CHATSWOOD TO SYDENHAM
**SYDENHAM STATION
AND SYDNEY METRO
TRAINS FACILITY SOUTH
MODIFICATION
SUBMISSIONS REPORT**

Purpose of this report

During public exhibition of the modification report, 15 submissions were received by the Department of Planning and Environment. The Secretary of Department of Planning and Environment provided copies of the submissions to Transport for NSW.

Figure 2-2 Sydney Metro Trains Facility South

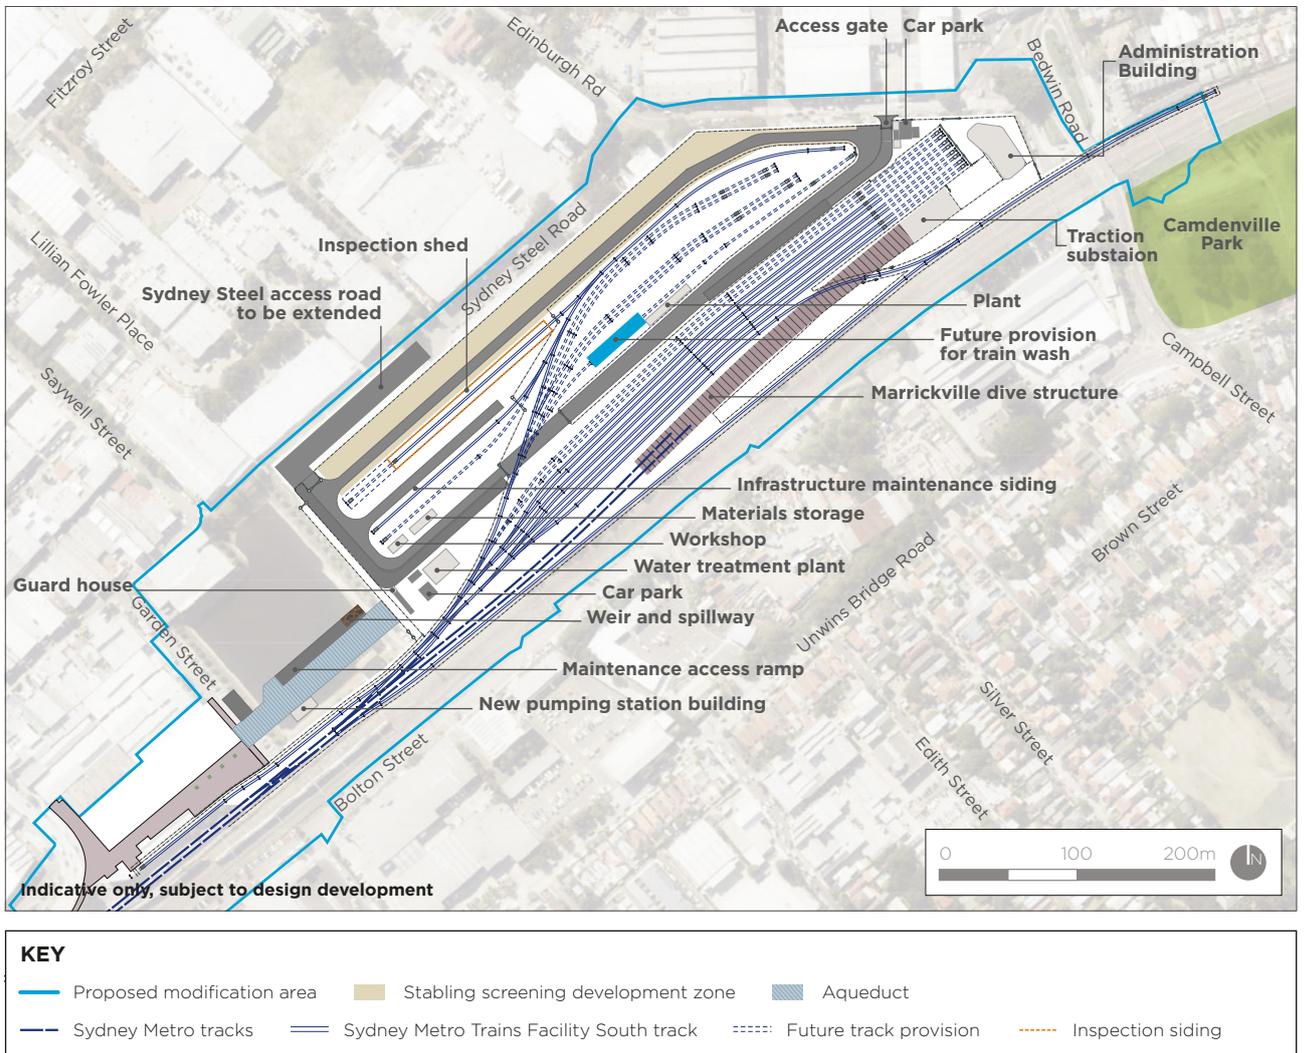
The approved Sydney Metro City & Southwest Chatswood to Sydenham project included a southern services facility (comprising a traction substation and an operational water treatment plant) adjacent to the Marrickville dive structure.

- The operational water treatment plant would be relocated to the southern portion of the site. This location is separated from the nearest residential receivers in order to limit potential odour impacts
- The traction substation would be relocated to above the dive structure.

The relocation of the water treatment plant also requires the relocation of the administration building from the location shown on Figure 6-2 of the modification report. The administration building would be located on the northern boundary of the site adjacent to Edinburgh Road. This would place the administration building adjacent to the proposed car parking area and avoid the need to staff and visitors to walk through an operational rail yard. Transport for NSW are currently working with Inner West Council regarding the façade treatment of the administration building where it interfaces with public roads.

The revised layout of the Sydney Metro Trains Facility South is provided as Figure 2-2.

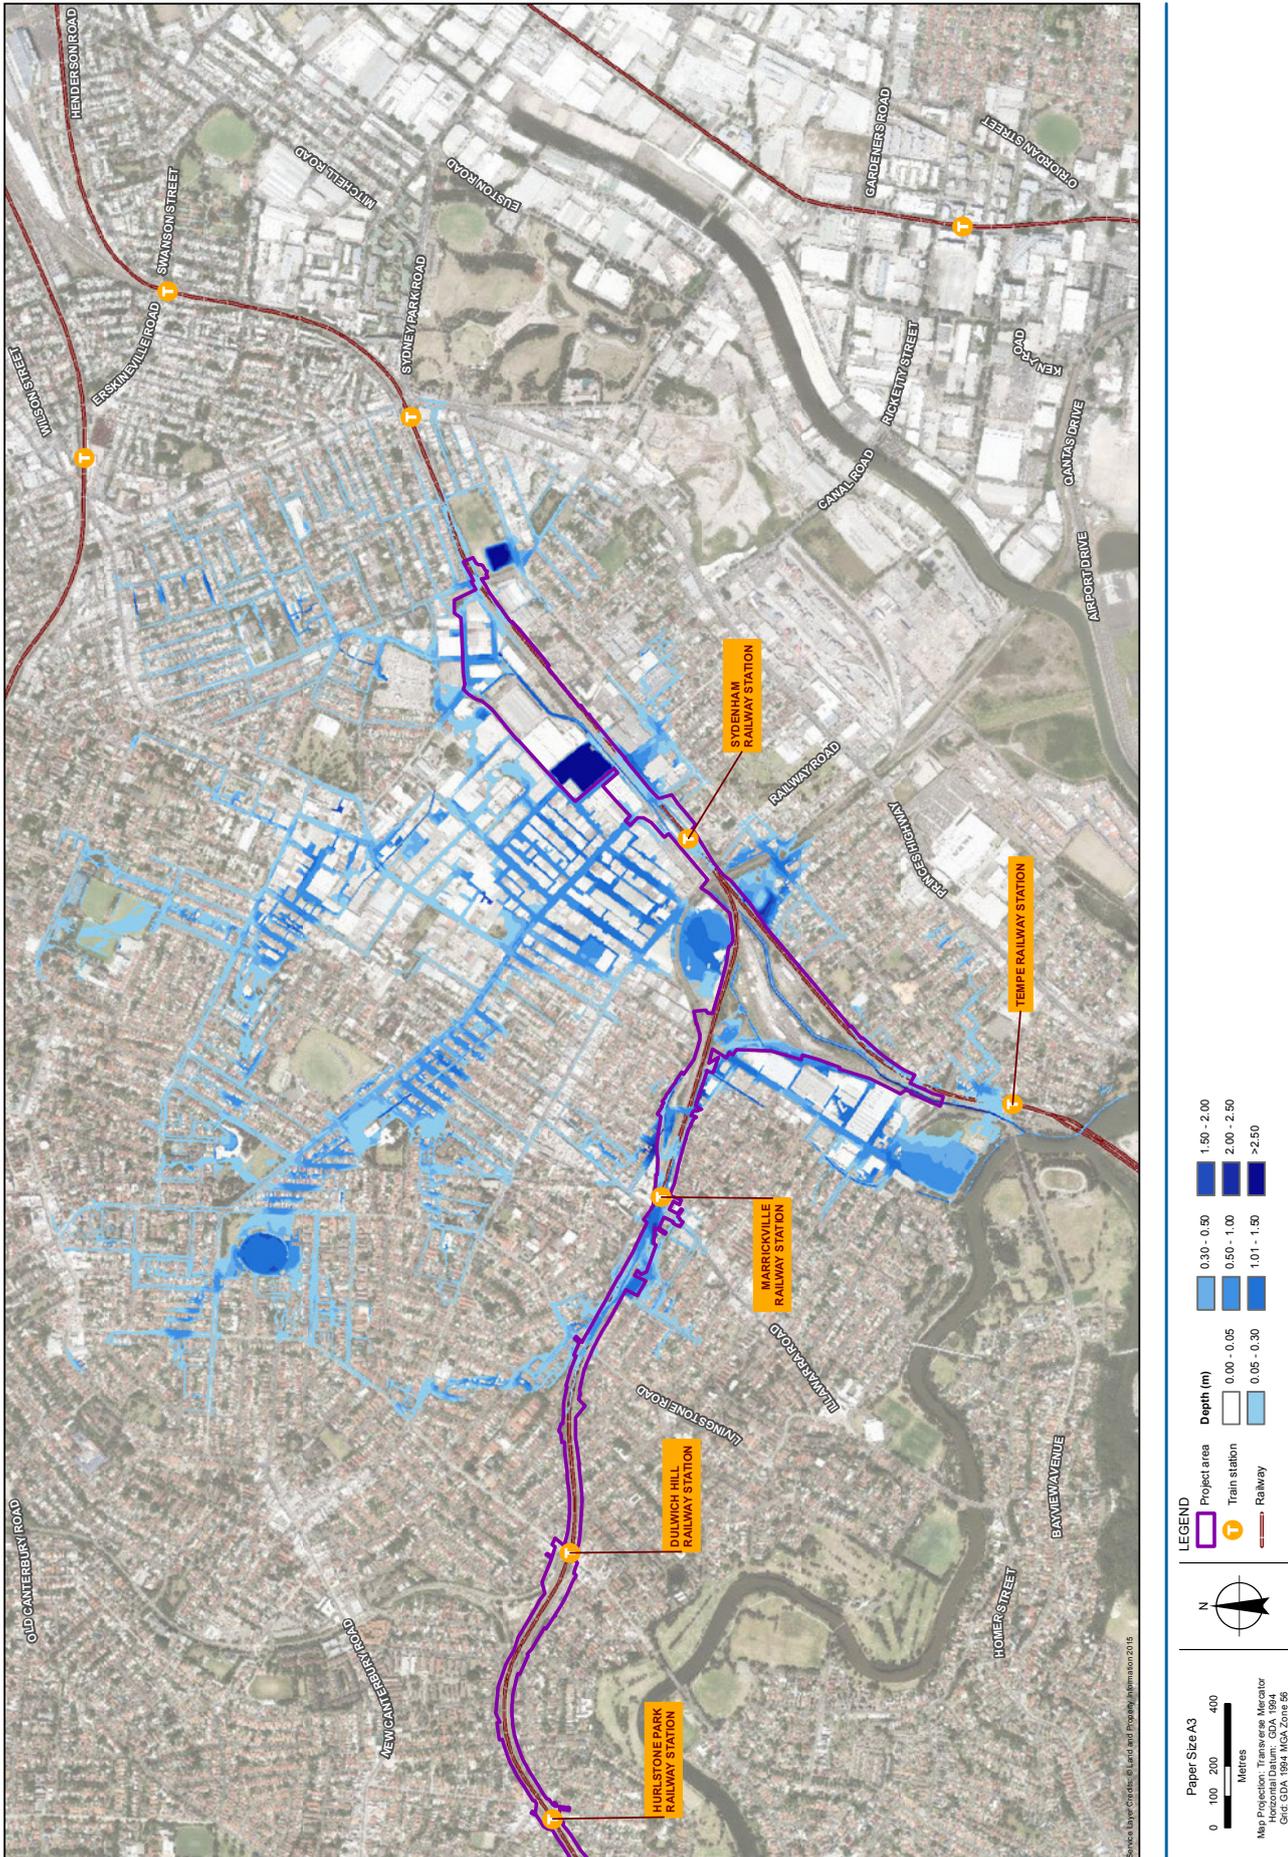
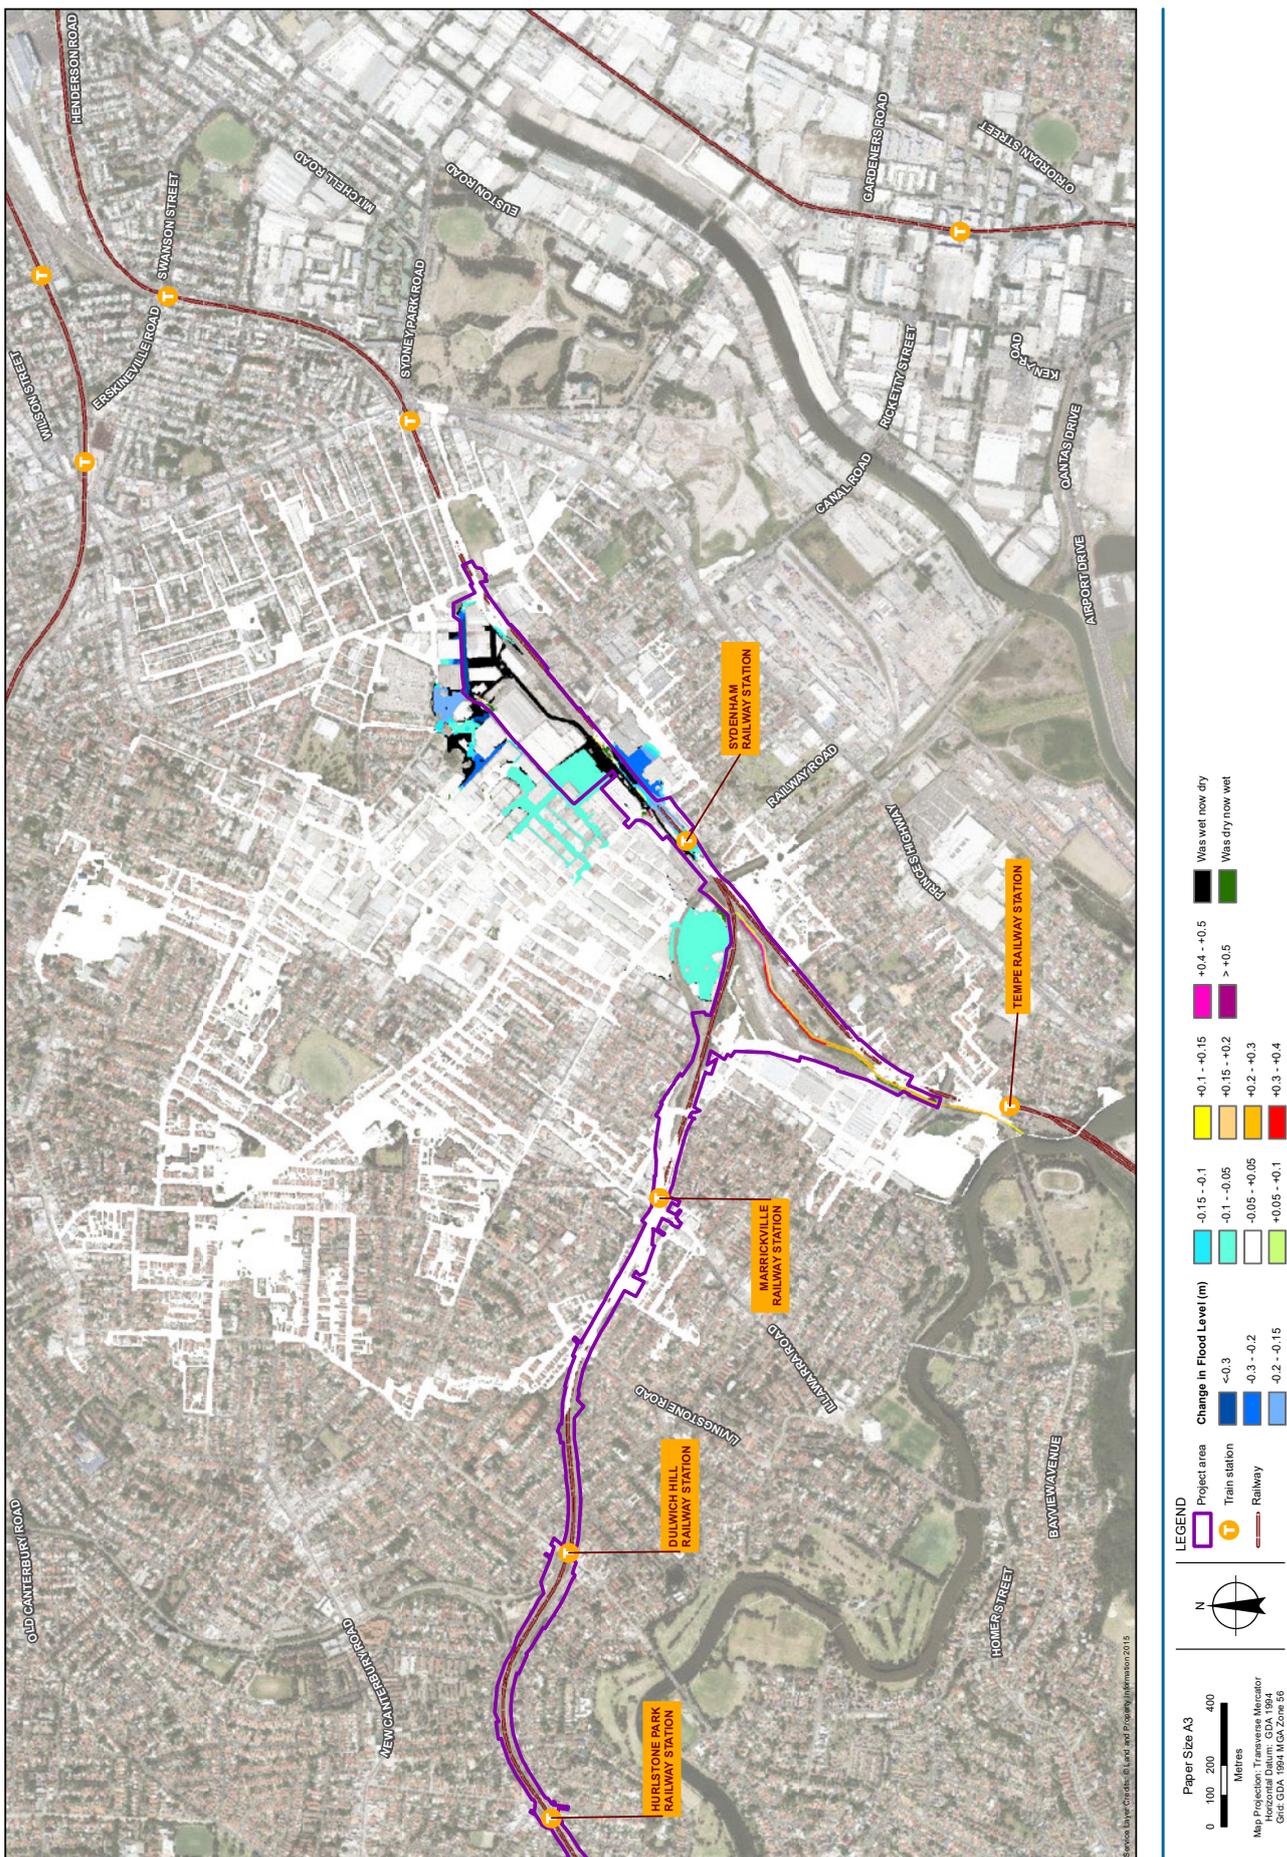
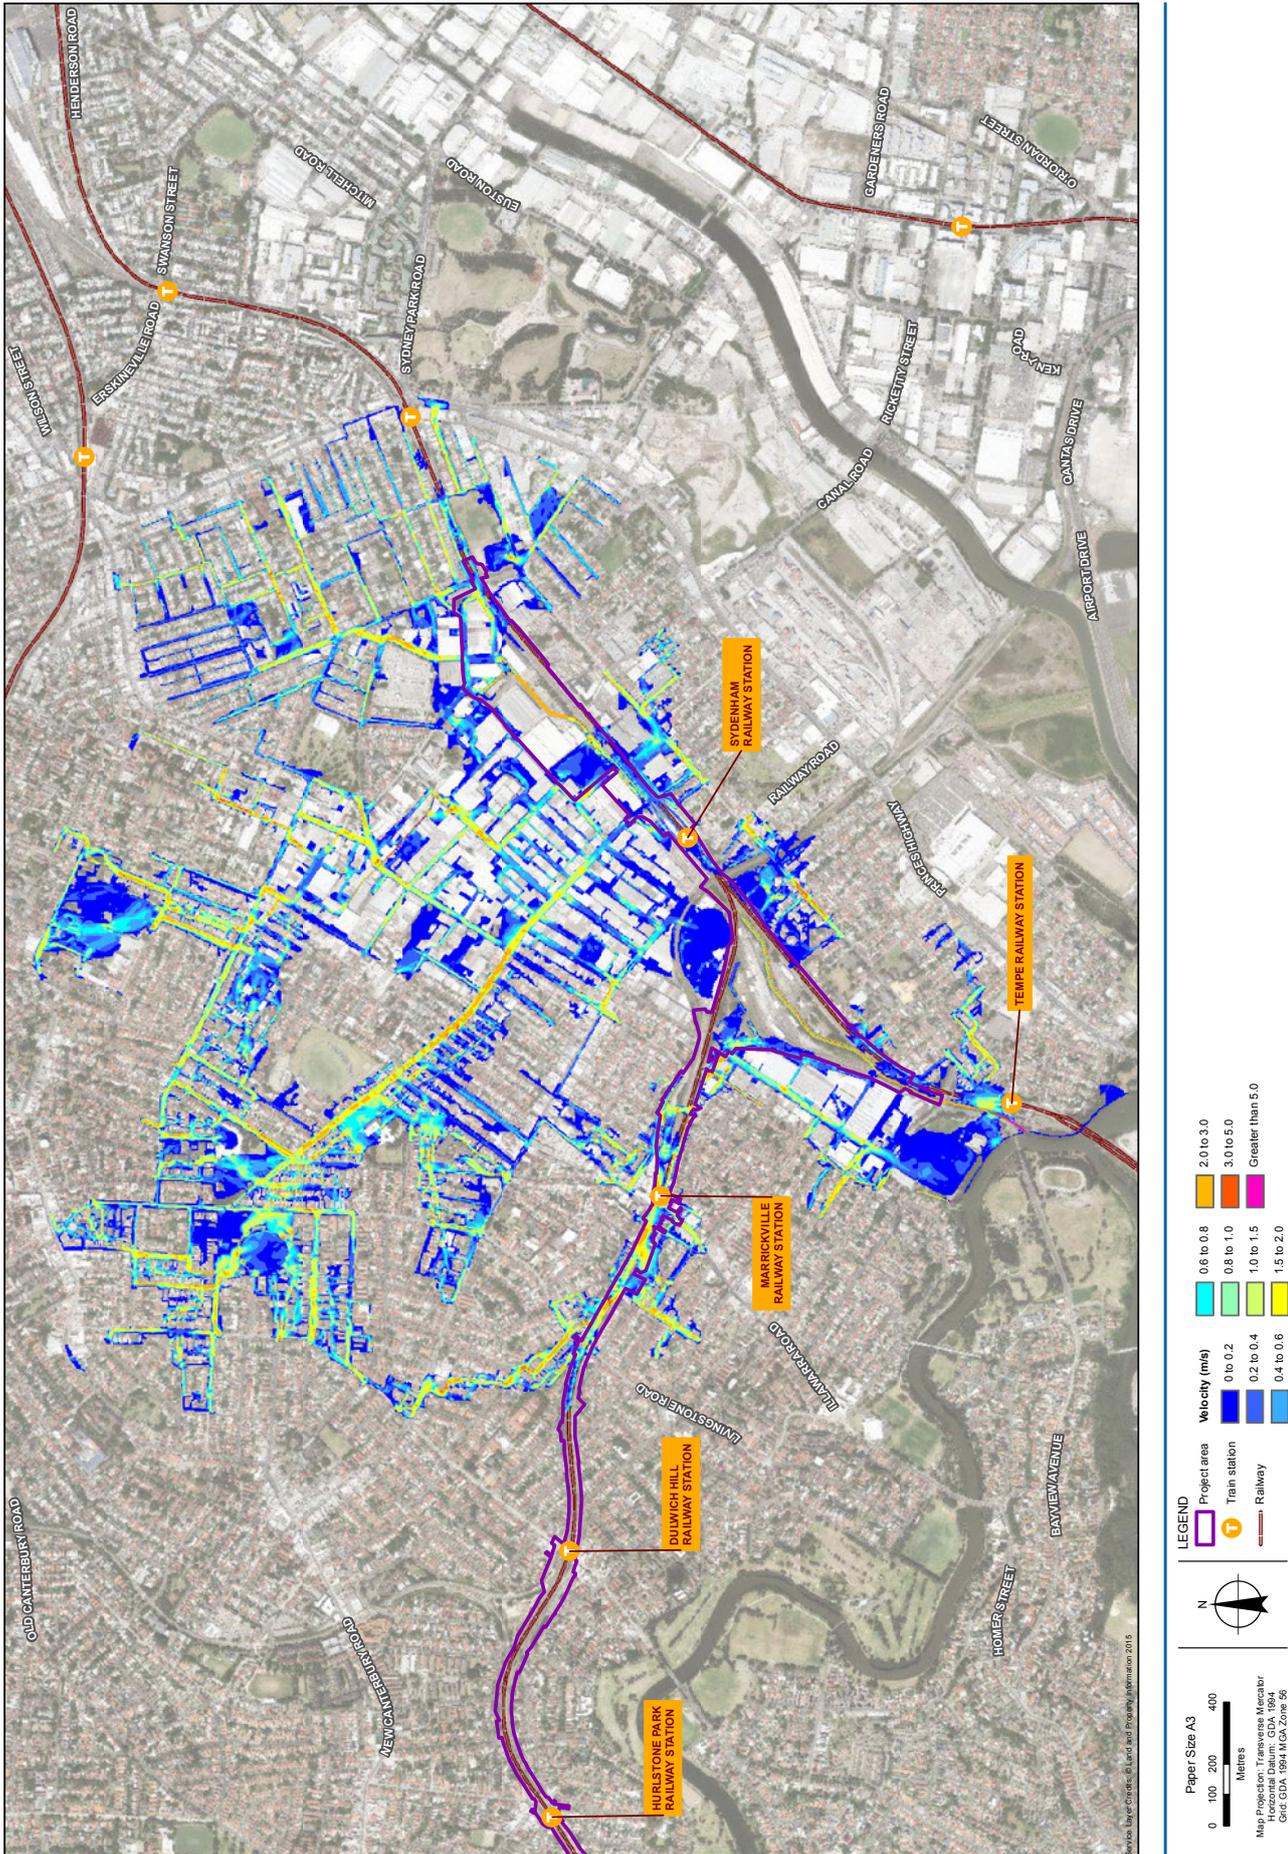
The modification report indicates that the modification will result in increases in flood depth and extent in the vicinity of Frederick and Sutherland streets. From a floodplain risk management perspective, it is prudent that the proponent adequately investigates the following:

- Identify additional properties that would be affected by over floor flooding in 1 per cent annual exceedance probability, which in existing conditions are subject to ground flooding only
- Identify additional properties that would be within the flood planning area, which are currently above the flood planning level
- Identify additional properties that would become flood affected due to the increase in the probable maximum flood extent
- Identify the potential for increase in flood damage due to the above points
- Address impacts on emergency management planning
- Undertake a consultation process with affected property owners and Inner West Council.

The modification report identifies that, with the proposed drainage and flood improvements in place, flooding impacts with the proposed modification would generally be less than those identified for the approved project. Notwithstanding, there is predicted to be an increase in flood depths in some locations, including on Sutherland and Fredrick streets. Additional technical information relating to the flooding assessment is provided in Appendix C.

- The one per cent AEP plus 10 per cent flood level change
- The one per cent AEP plus 10 per cent velocity change
- The one per cent AEP plus 10 per cent provisional flood hazard
- The PMF flood level change (as was provided in the modification report)
- The PMF velocity change
- The PMF provisional flood hazard.

This additional mapping does not change the outcomes of the flooding assessment provided in the modification report. Additionally the mitigation measures, which provide a performance standard for the project, would continue to apply.
